**Consumers
Power
Company**

RELATED CORRESPONDENCE

Attached are copies of audit reports and of certain other documents recently issued by the MPQAD.

AUDIT REPORTS

RESIDENT ENGINEER
COMMENT

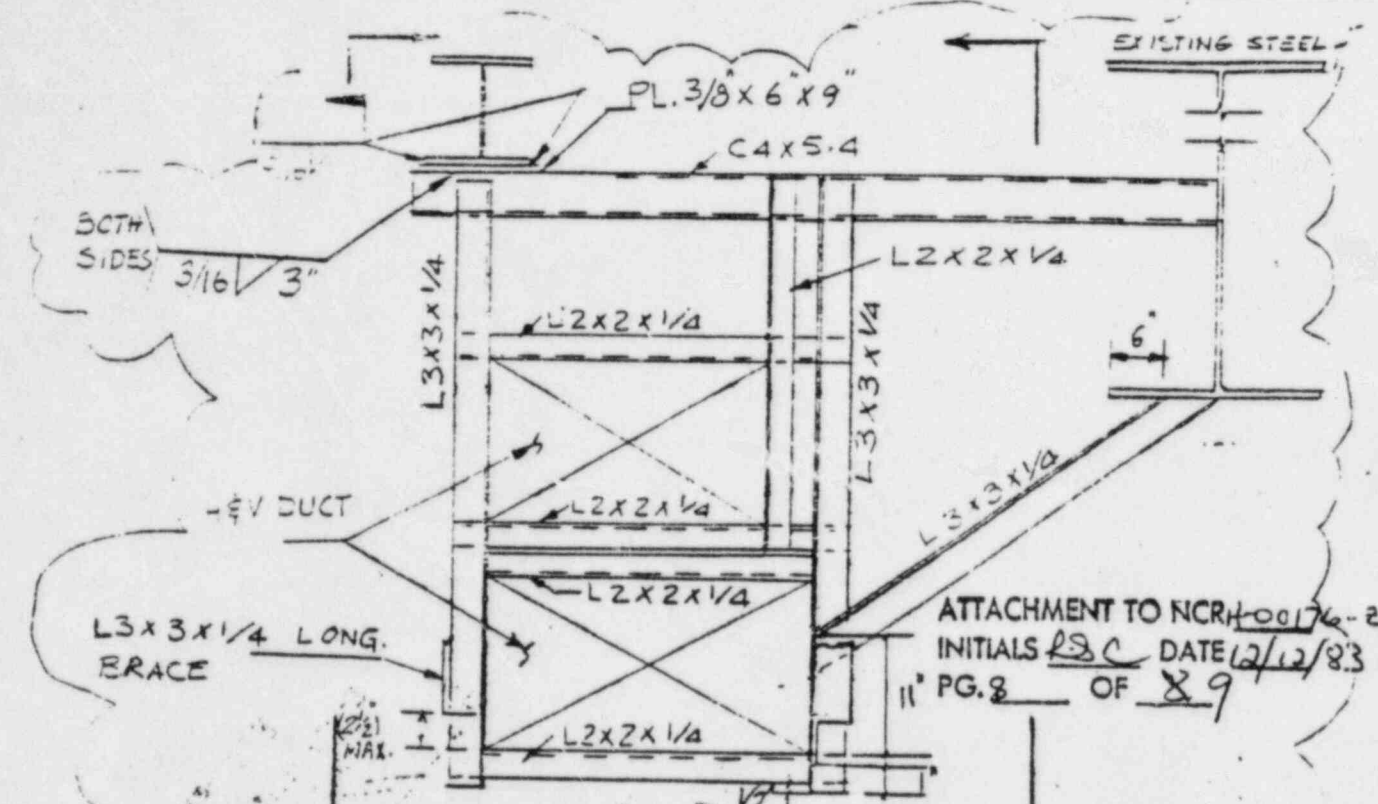
Contrary To The Above Requirements FCN C-878 Notes Revisions To Be Made To Plan Drawing C-935(Q) But The Changes Have Not Been Incorporated.

DESCRIPTION OF CHANGE
SEE DRAWINGS REV. 3
1. PAGE 2 THIS FCN IS VOID.
2. REVISE DWG. C-929(Q) PER PAGES 3, 4 & 5 THIS FCN
ATTACHMENT TO NCR H-00176-22 INITIALS PSC DATE 12/18/83 PG. 3 OF 89
ON PLAN DWG. C-935(Q) REV. 3 APPROX. LOC. 39'-8" E / 1/2" OF RB1 AND 33'-7" S / 1/2", CHANGE CALLOUT TO READ:
7 REVISE PER C-929 FCN C-818 SHT. 6
RESIDENT ENGRS COMMENT

REMARKS APPROVED WITH COMMENTS. DRAWING C-929 (Q) WILL BE REVISED. NO DRVC ISSUED. BC
Tel. 625-2500 AQ 12/30/81

ELEVATION - LOOKING NORTH

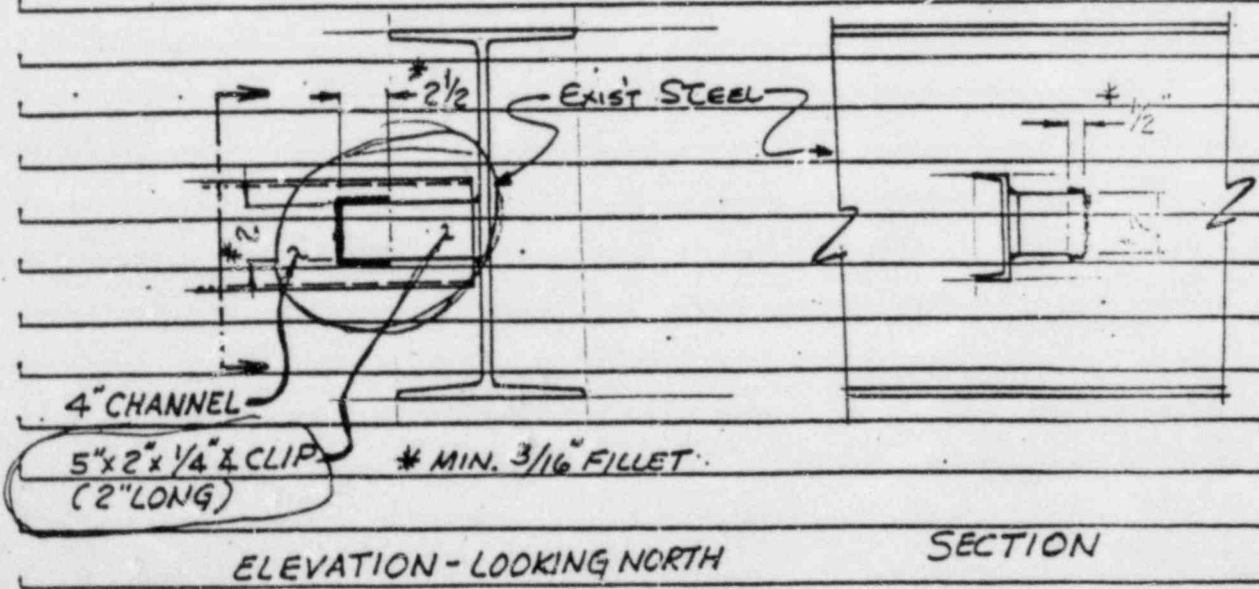
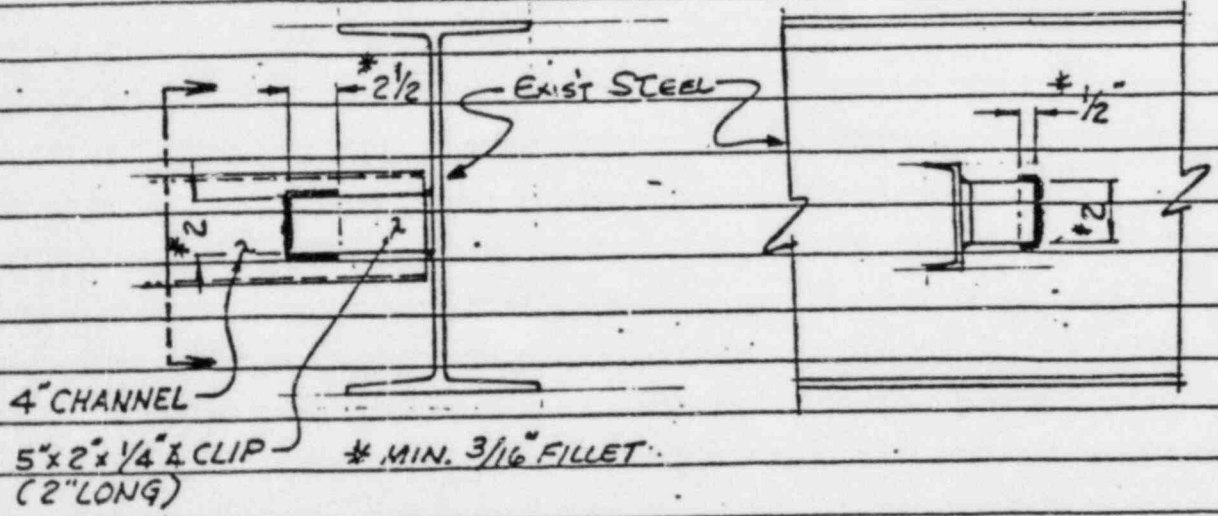
1. Contrary to above, Hanger 10 has the channel welded to a 2" x 2" x 1/4" angle clip and the clip welded to existing steel. Neither Detail 7/C898 Revision 16 or Floor Plan Drawing C863 Revision 20 references the clip used. (see attached sketch)

8. DESCRIPTION OF NONCONFORMANCE of inspection. ① Detail 7/C898 requires the channel to be welded to the existing steel with a 3/16" fillet weld 2" long on two sides.
② Contrary to the above, Hanger 10 V22h2 F6342 has the channel welded to a 2x2x1/4" clip and the clip welded to existing steel. Neither the detail drawing (detail 7/C898 Rev 16) nor the floor plan drawing (C863 Rev 20) references the clip used.

THIS NCR WAS A RESULT OF AN OVER INSPECTION OF A PREVIOUSLY ACCEPTED HANGER. ITEMS ON THIS NCR WERE LISTED ON A PREVIOUS NCR (NCR# A 885, CLOSED 4/15/81). THE ACTUAL CUP SIZE IS 2"x5"x 1/4" & 2" LONG.

SECTION

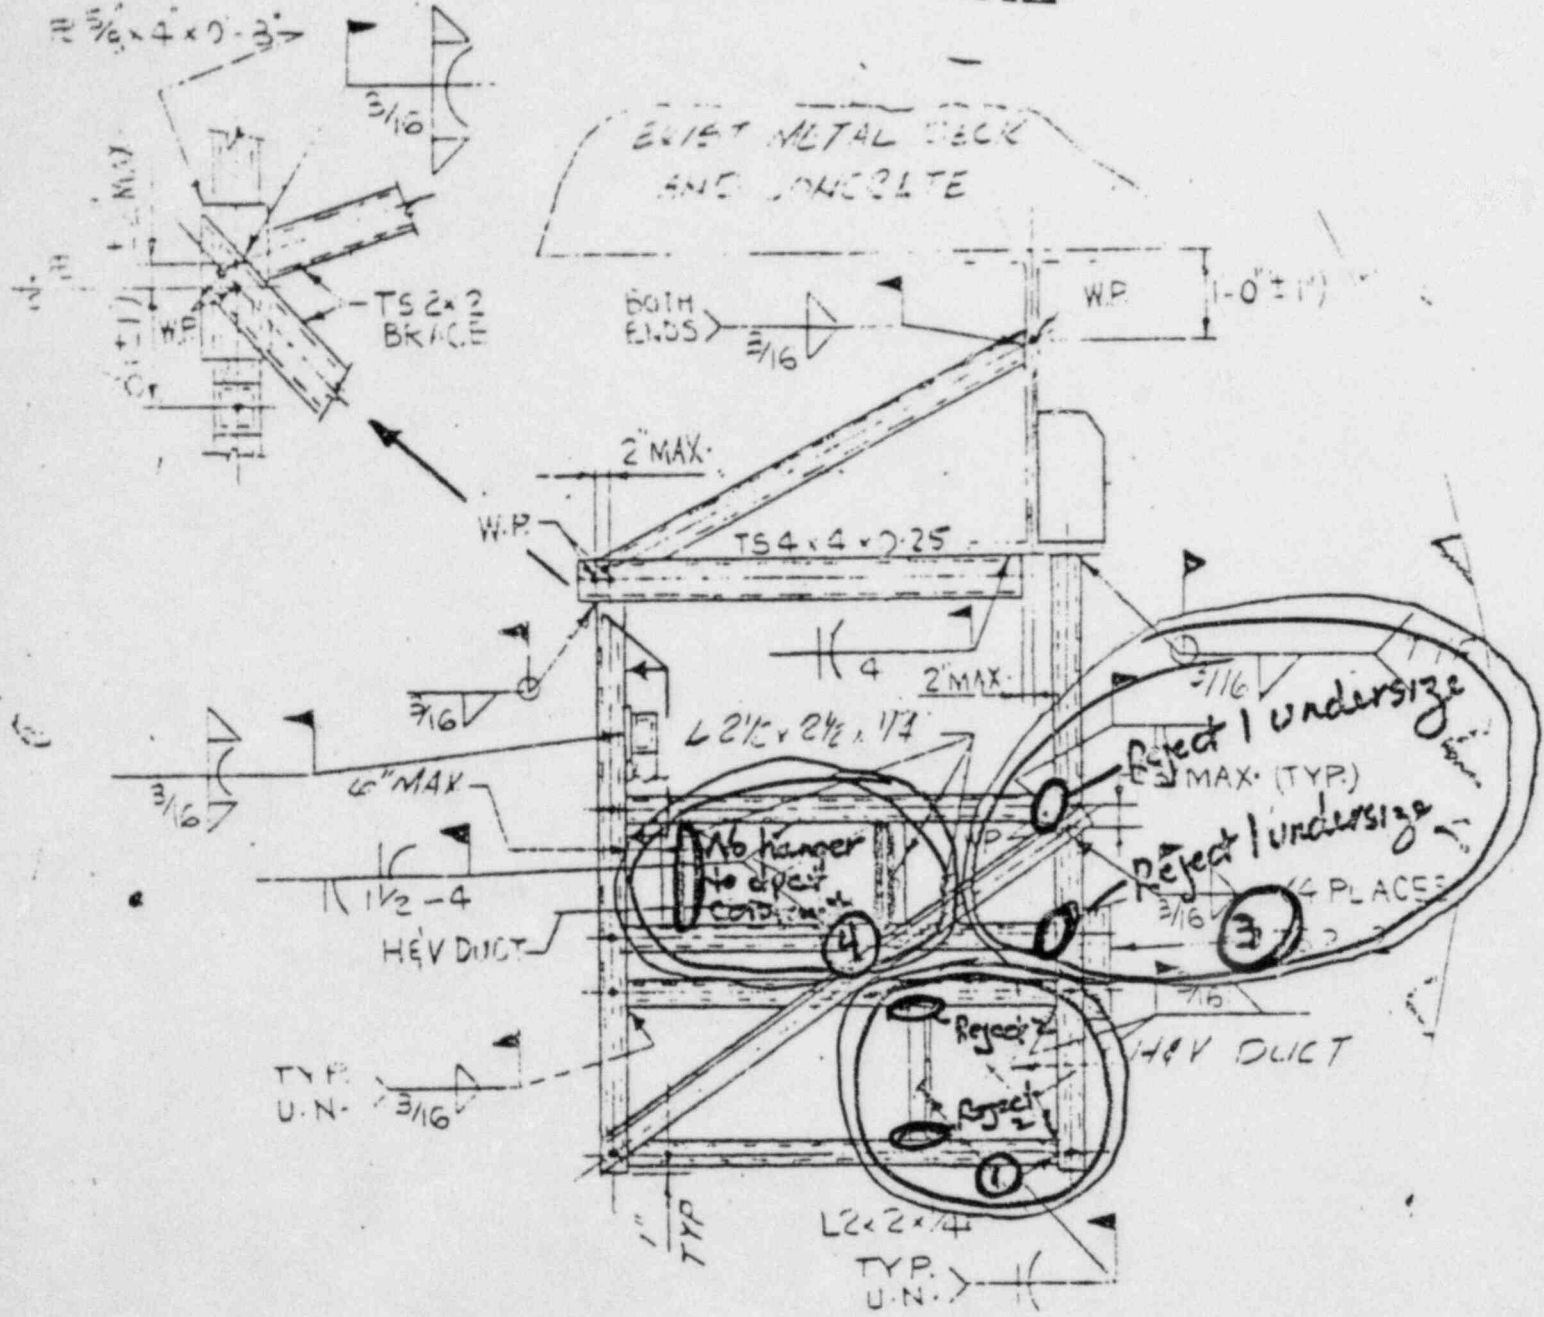
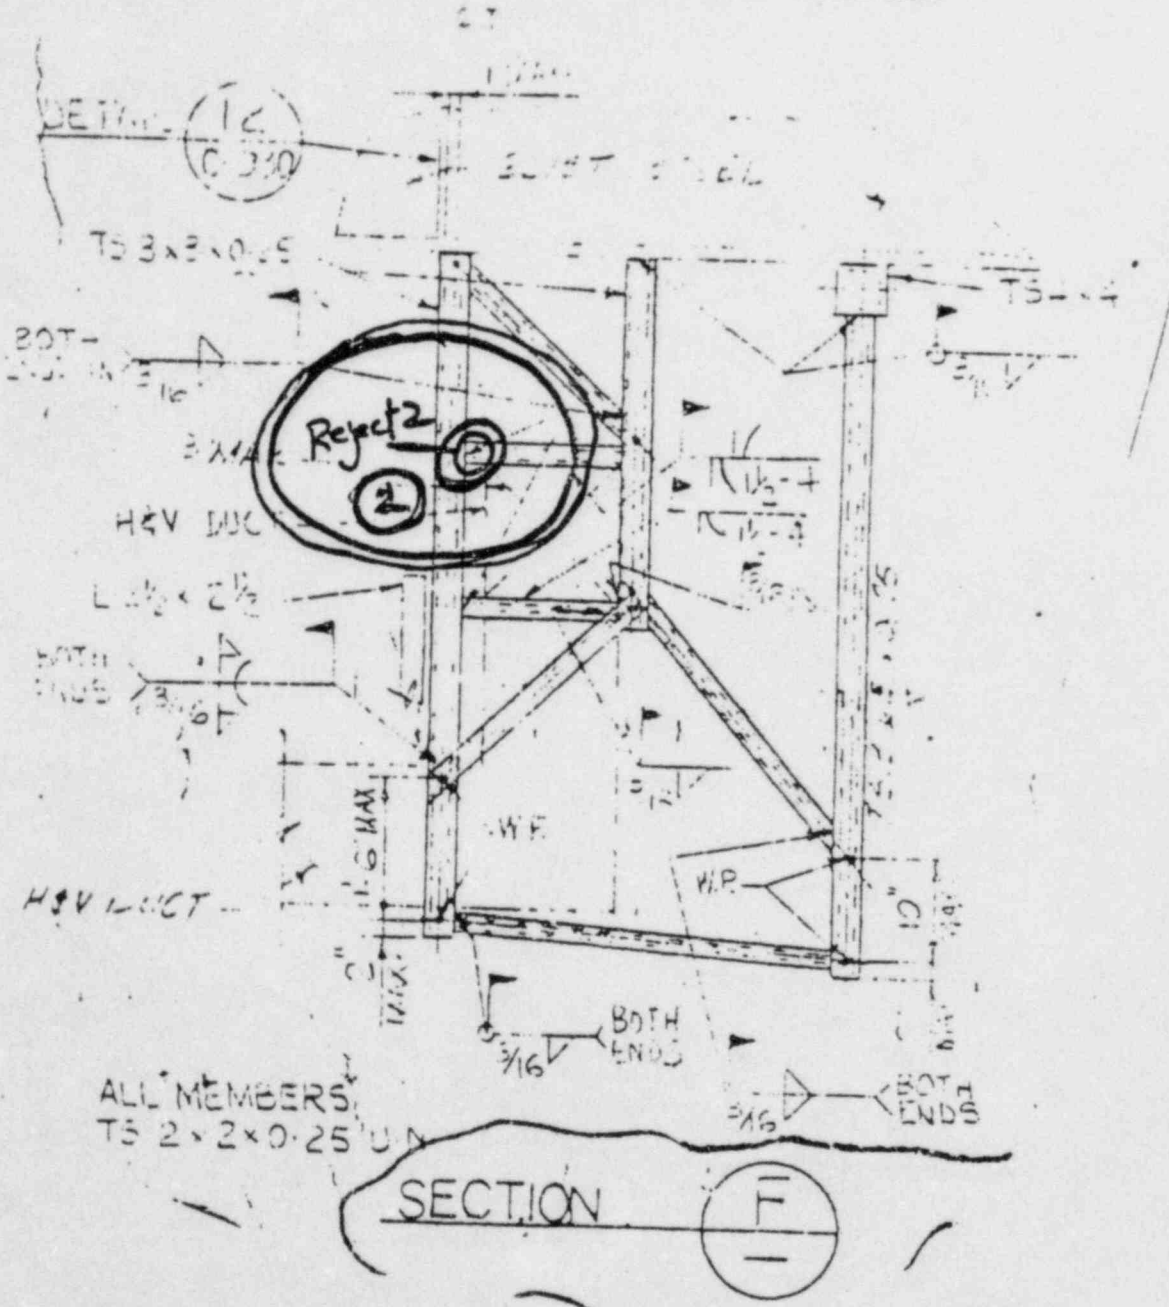
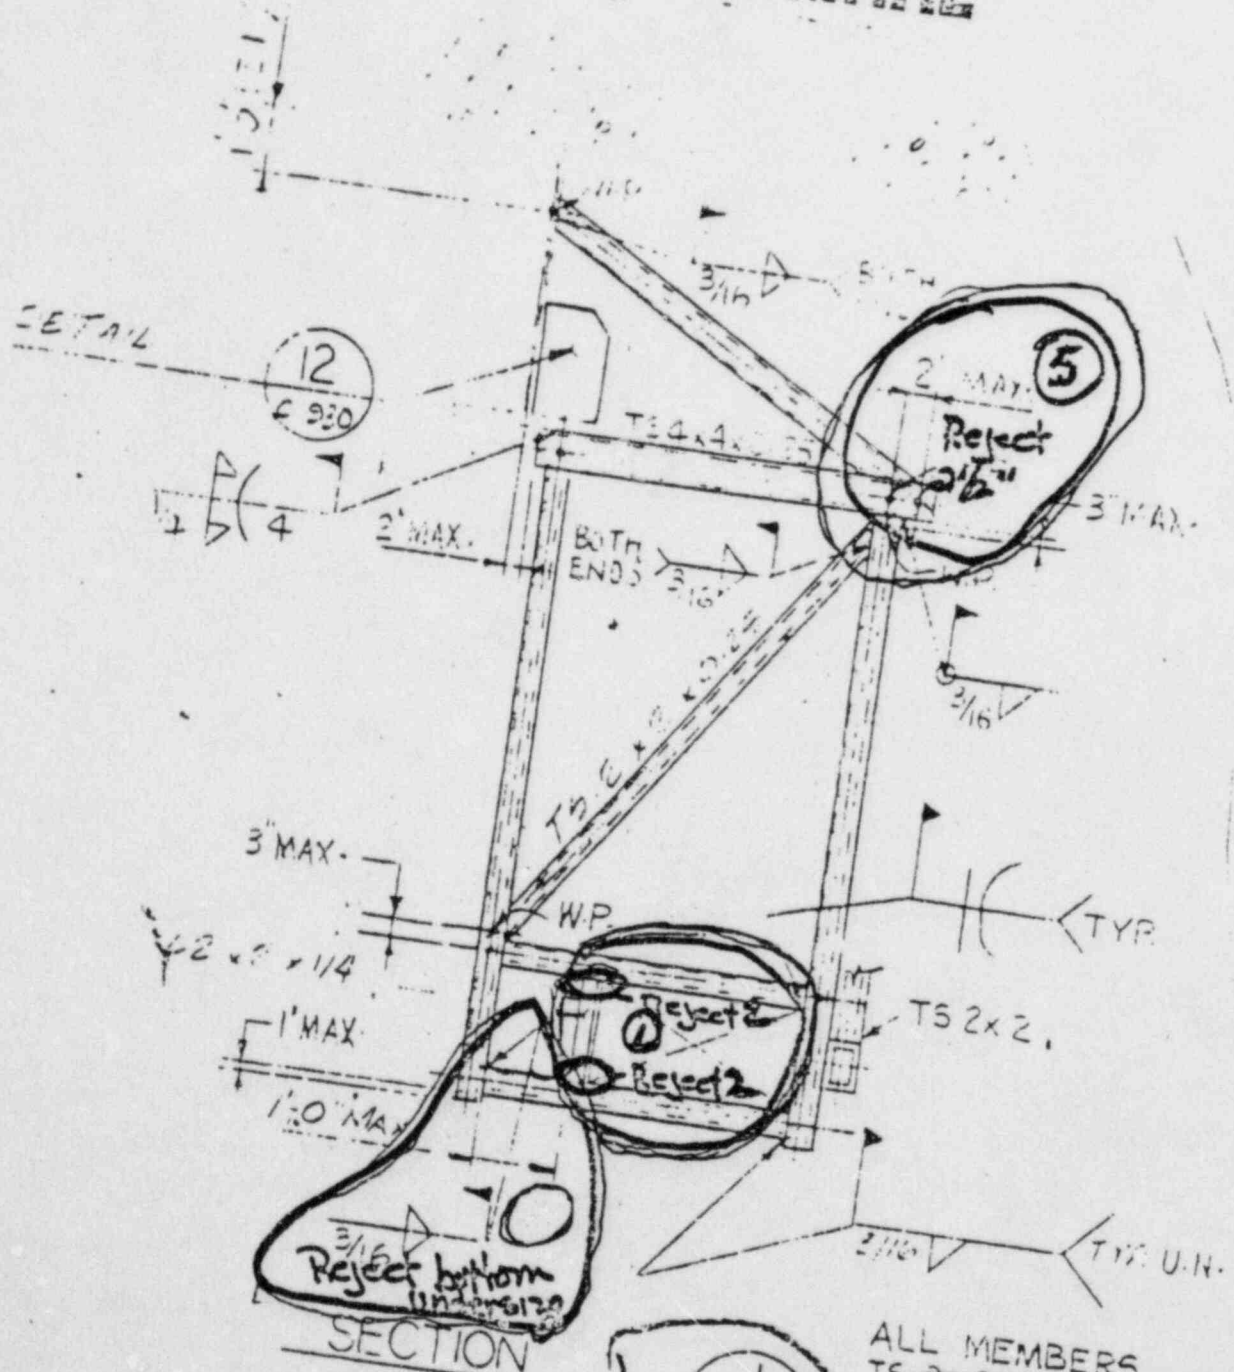
- Contrary to the above, Section "J" (Detail 3/C953) and Section "G" (Detail 3/C953) has 2" x 2" angle with both welds on the inside leg of the angle. (see attached sketch)
- Contrary to the above, Section "F" (Detail 3/C953) has 2" tube steel that is not welded on the rounded corners thus not providing a total of 4" of weld. (see attached sketch)
- Contrary to the above, Section "J" (Detail 3/C953) has one weld undersize by over 1/16". Section "G" (Detail 3/C953) has two welds undersize. (see attached sketch)
- Contrary to the above, Section "G" (Detail 3/C953) (continued on page 3)

4. has two angles not in contact with duct run. (see attached sketch)

5. Contrary to the above, Section "J" (Detail 3/C953) shows a 2" maximum between work points, contrary to Detail 2 1/2" was provided. (see attached sketch)

BECHTEL PROJECT ENGG HAS EVALUATED ITEM #1 AND DISPOSITIONS "USE-AS-IS".
THIS ITEM IS A ONE-TIME DEVIATION TO DETAIL 3K-953 & NO LONGER A
NON-CONFORMANCE. NO DWG OR SPEC CHANGE IS REQD. THE WELD PROVIDED
IS SUFFICIENT (REF: CALC 21-I(6.105)(Q) REV-1). A DRVC HAS BEEN
ISSUED. NOT APPLICABLE TO QUAL-TEST.

10. CORRECTIVE ACTION PLAN ③ Rework welds per detail 3/C953 Section J & G WPS (2-1-1) or 2-1-2 WELDER ID# HVO20 ④ Angles shall be cut loose and moved into contact with duct & rewelded WPS (2-1-1) or 2-1-2 WELDER ID# HVO20 ⑤ Not a nonconformance, dimension is actually 1 1/8". RJA 7-26-83

DETAIL IIA

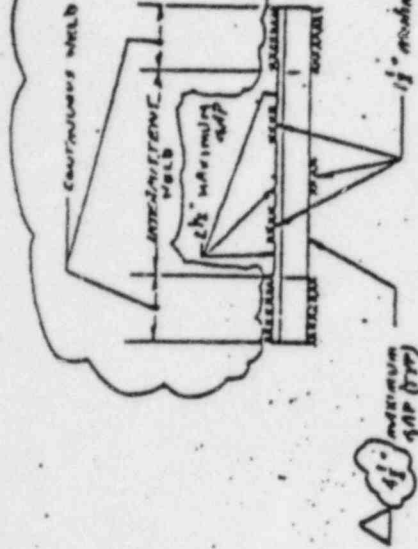
1) DRAWING C849 REV. 19 SECTION "A" REQUIRES COMPANION FLANGE TO DUCT WELDS TO BE 1/8" FILLET 1 1/2" LONG ON 4" CENTERS.

DRAWING C846 REV. 12 DETAIL 11A SHOWS HOW TO MEASURE WELDS FOR 1 1/2" LONG ON 4" CENTERS PER DCU #10.

1) COMPANION FLANGE TO DUCT WELDS DO NOT MEASURE OUT TO BE 1 1/2" ON 4" CENTERS AS CALLED OUT ON DRAWING C849 REV. 19. DCU 10 TO DRAWING C846 REV. 12 CLARIFIES METHOD TO BE USED TO DETERMINE IF CENTER TO CENTER SPACING IS ACCEPTABLE. WHEN DCU 10 WAS INITIATED A RETRO-ACTIVITY DATE OF 09/09/83 WAS PUT ON THE WELDING CRITERIA. THE NCR THAT ORIGINALLY ADDRESSED THIS NONCONFORMANCE (BACK NCR #A2094 WAS INITIATED ON 09/02/83 THEREFORE THE CENTER TO CENTER SPACING OF WELDS ON DUCT # 303A IS STILL NONCONFORMING KSC 09/17/84

REVISE DETAIL IIA OF DWG C-846(G) AS SHOWN ON SHR 2 OF 2.

DETAIL ID

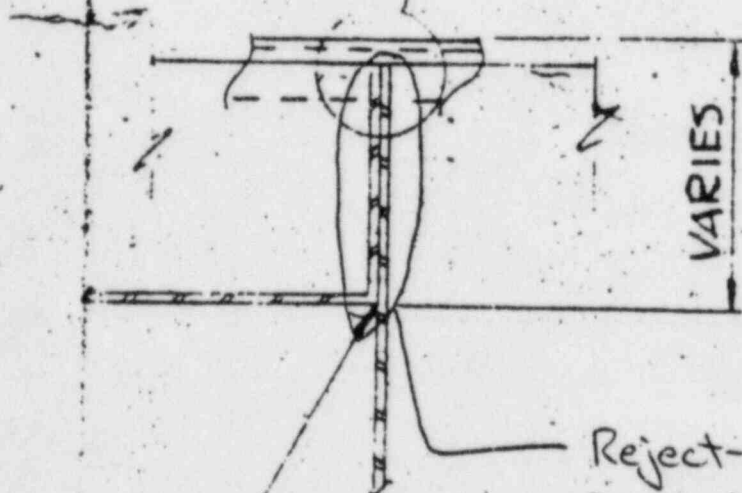
1. Tech. Spec. 7220-M-151A(Q) Rev.18 para. 10.2.1 states, "Duct hangers and supports shall be fabricated as shown on the drawings."
2. Drawing C-846(Q) Rev.12 Detail 1C requires that a continuous weld be utilized on three sides of the juncture of the two duct pieces in a nested fitting configuration.

Reject- Bottom of
Duct is stitch welded.
